# NRC Salt Waste Monitoring Open Item Status

**April 26, 2011**

SRR-CWDA-2011-00043

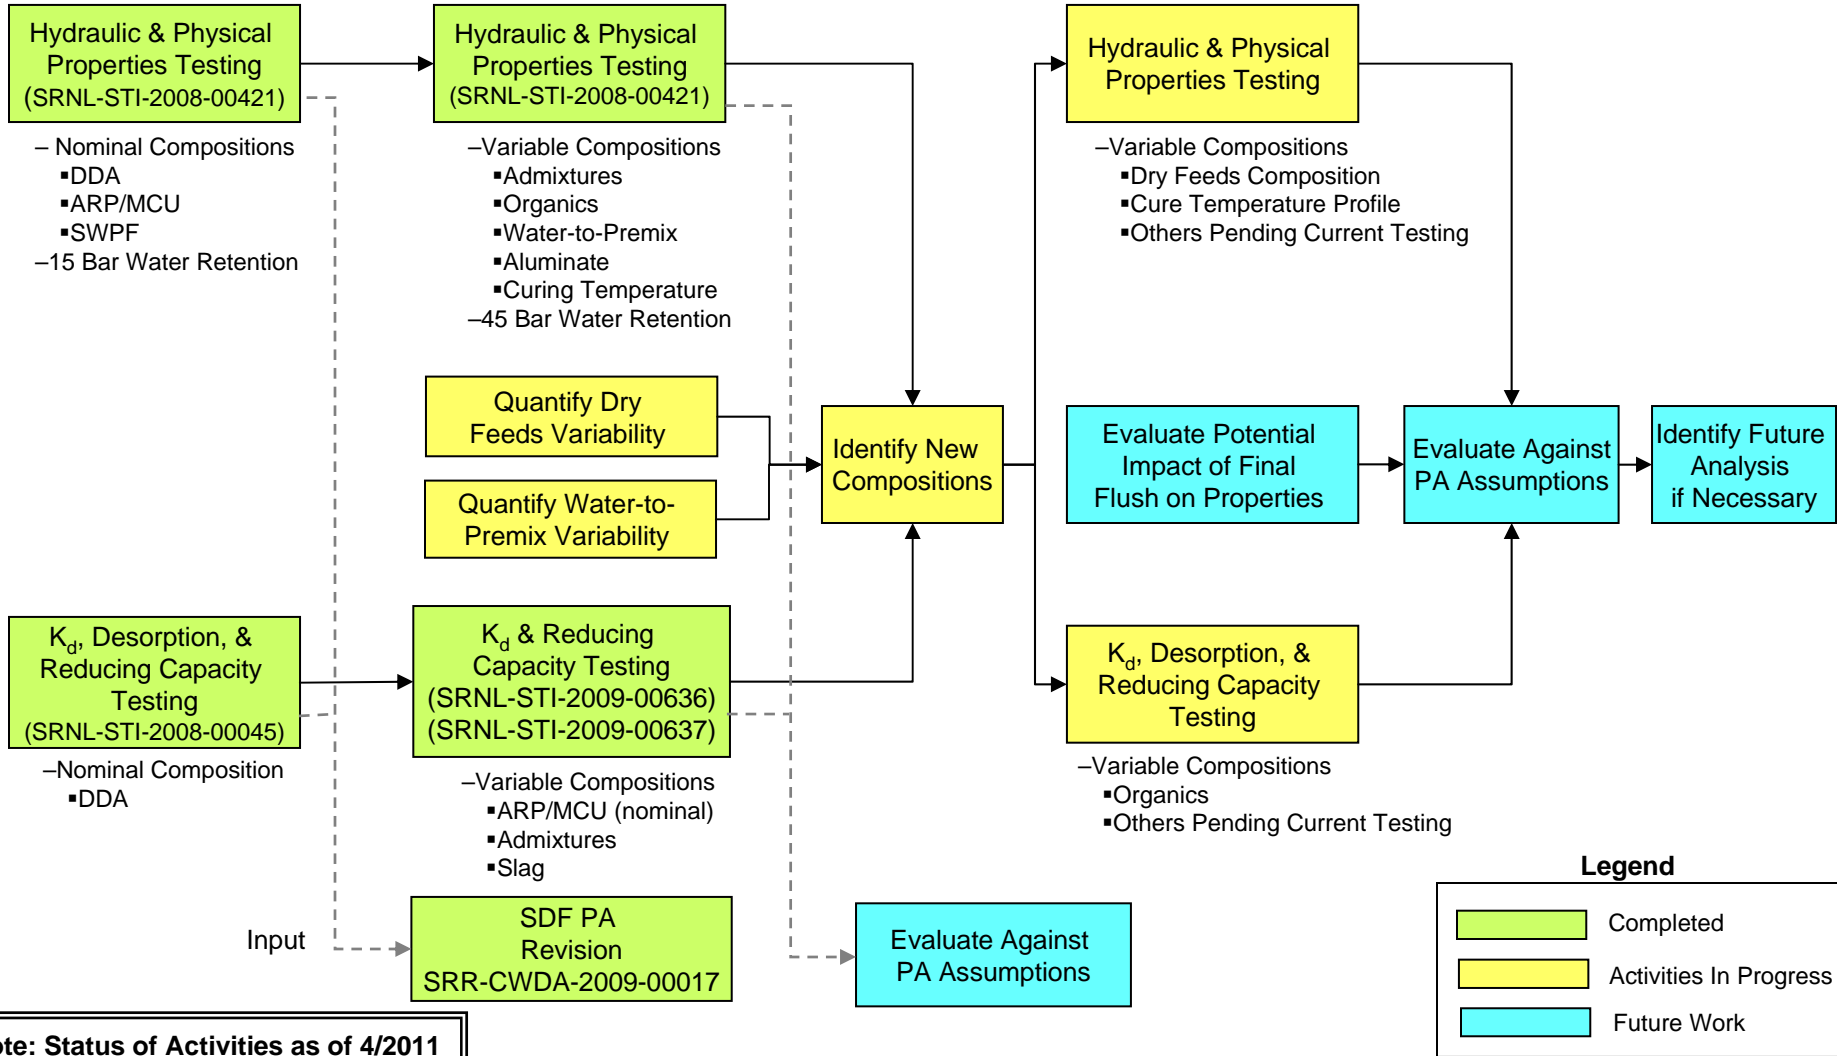
- Issue
  - *At the SRS Saltstone Facility, as a result of variations in the composition of saltstone grout actually produced at the SRS SPF, DOE should determine the hydraulic and chemical properties of as-emplaced saltstone grout.*

- *At the SRS Saltstone Facility, DOE should demonstrate that intra-batch variability, flush water additions to freshly poured saltstone grout at the end of each production run, and additives used to ensure processability are not adversely affecting the hydraulic and chemical properties of the final saltstone grout. DOE should show that the hydraulic and chemical properties are consistent with the assumptions in the waste determination or show that any deviations are not significant with respect to demonstrating compliance with performance objectives.*

- Update
  - Core sample  $K_d$  testing is complete and available for NRC review.
  - Alternate sampling methods evaluation is complete and formed core sampling has been selected as the preferred alternative. NRC has requested additional evaluation of this technique (see Follow-up Action below).
  - Integrated sampling plan outlining future sampling and correlation of laboratory prepared saltstone to as-emplaced saltstone is the final step in developing a comprehensive sampling program. This activity will be integrated with the new disposal unit schedules.
    - Initiating integration with the Project Team and Design Authority to move from concept to the field.

Total Scheduled	27
Prepared	24
Tested	17

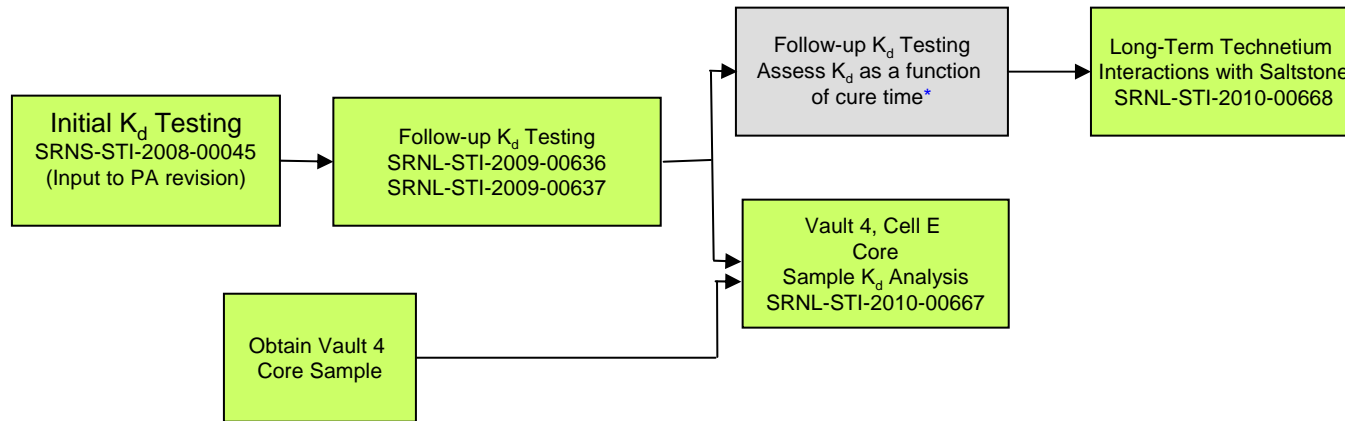
- *What cure temperatures have been observed since 2007 and what is the anticipated cure temperature based on the increase in aluminate concentration?*

- SRS has no specific plans to evaluate the impact of aluminate on cure temperature.
- Cure temperature profiles from saltstone production are being assembled and will be evaluated for use in subsequent testing.
  - Note: Cure temperature as a function of time may be as important to overall saltstone performance as the maximum data point recorded.
